ADDENDUM NO. 2  
TO  
PLANS AND SPECIFICATIONS  
FOR  
EDITH KANAKA'OLE MULTI-PURPOSE STADIUM  
BUILDING ADDITION & IMPROVEMENTS  
JOB NO. PR-4166  
SOUTH HILO, HAWAII  
COUNTY AND STATE OF HAWAII

**NOTICE TO BIDDERS**

**SINGLE LINE DIAGRAM - EXISTING/BASE BID/ADD. ALT. #2**  
**NO SCALE**

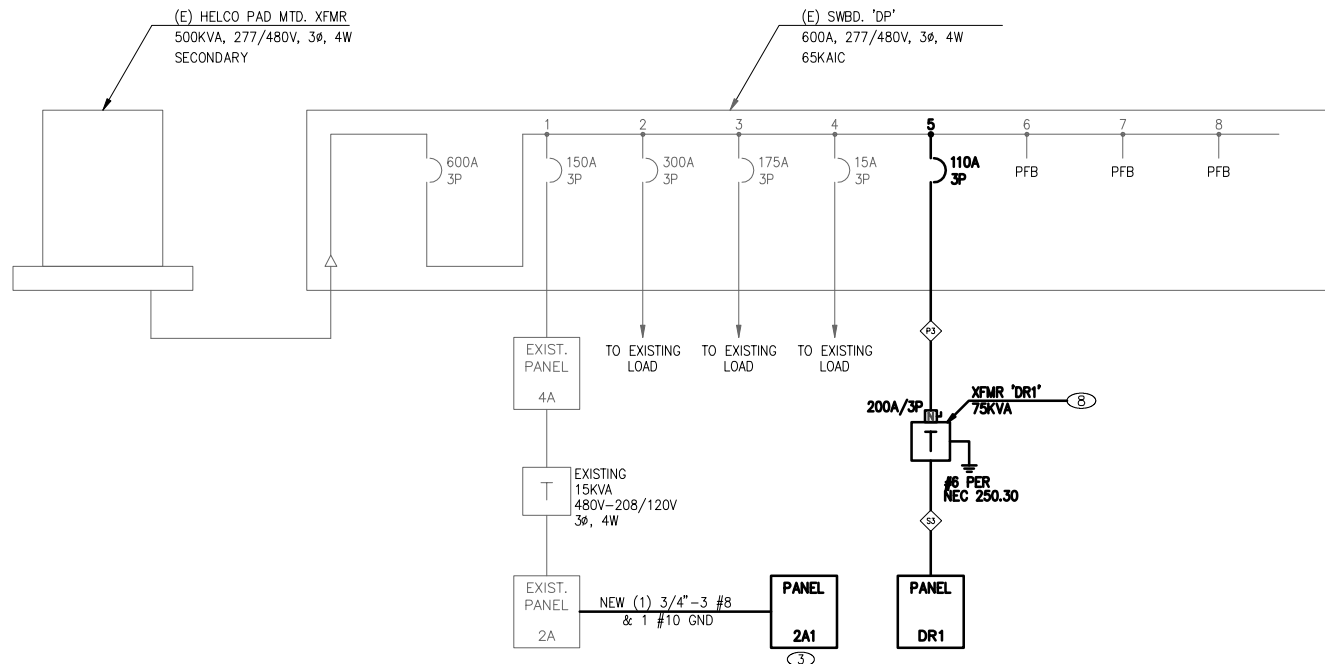
1. **QUESTION:** *What is the brand of the existing switchboard DP?*

**RESPONSE:** Cutler Hammer Type VB Switchgear, Serial Number 5LF775290A, 277/480V, 3ph, 4W, 800A.
